Request of Class II Permissive Change

Company name: Anker Innovations Limited
FCC ID: 2AOKB-T8503
FCC Part 15 Certification

This is to request a Class II Permissive Change for FCC ID: **2AOKB-T8503** originally granted on 08/27/2021

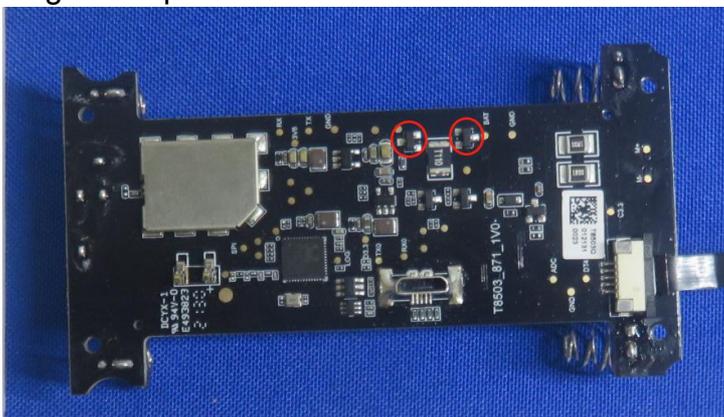
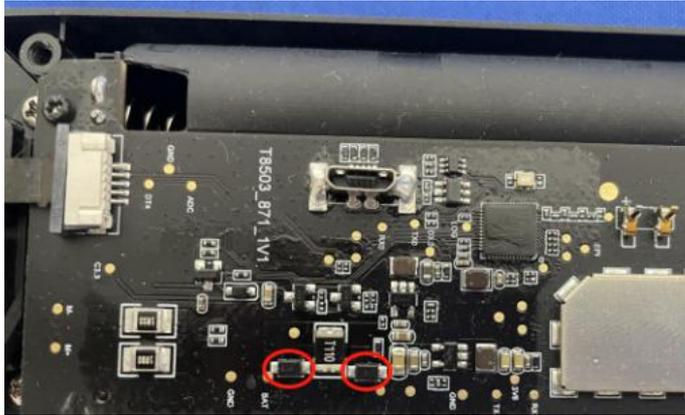
- (1) Change the product name to "eufy Security Smart Lock R10"
- (2) Change the transistor to a diode, and change the PCB board. Change the tag number from Q6, Q7 to D3, D4.
- (3) Change the HW Version to V1.1
- (4) Change the SW Version to 1.0.2.3

Original chip:

Update chip
